Service Bulletin

Bulletin No.: PI1134

Subject: Installation of Rear Compartment Lid ECO Emblem for Customer Satisfaction

Models: 2014 Chevrolet Malibu Equipped with Engine RPO LKW
Condition/Concern

3656813

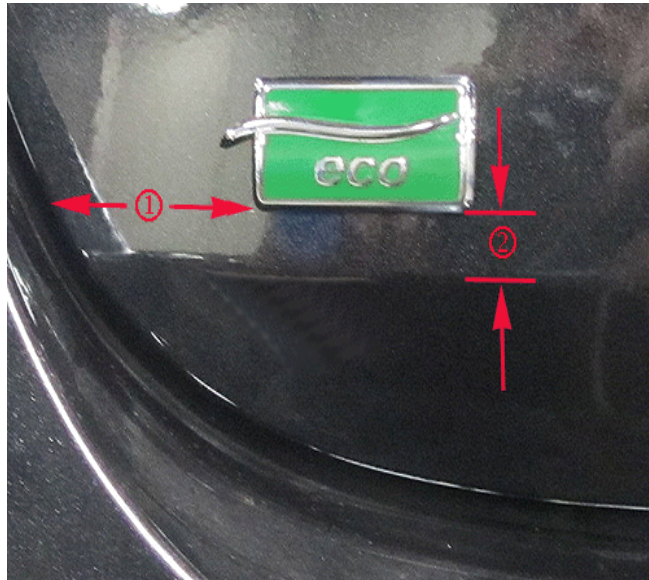
An ECO emblem has been added to the left side of the rear compartment lid (deck lid) on the 2014 Malibu equipped with a LKW engine.

Some vehicles may have been manufactured without the emblem.

If a customer is concerned that their vehicle does not have the ECO emblem, the emblem can be installed for customer satisfaction.

Note: eAssist (RPO HP6) Malibus have an ECO emblem on the right side of the rear compartment lid. This is correct for vehicles with eAssist (RPO HP6). The emblem has been relocated to the left side for the 2014 vehicles with the LKW engine.
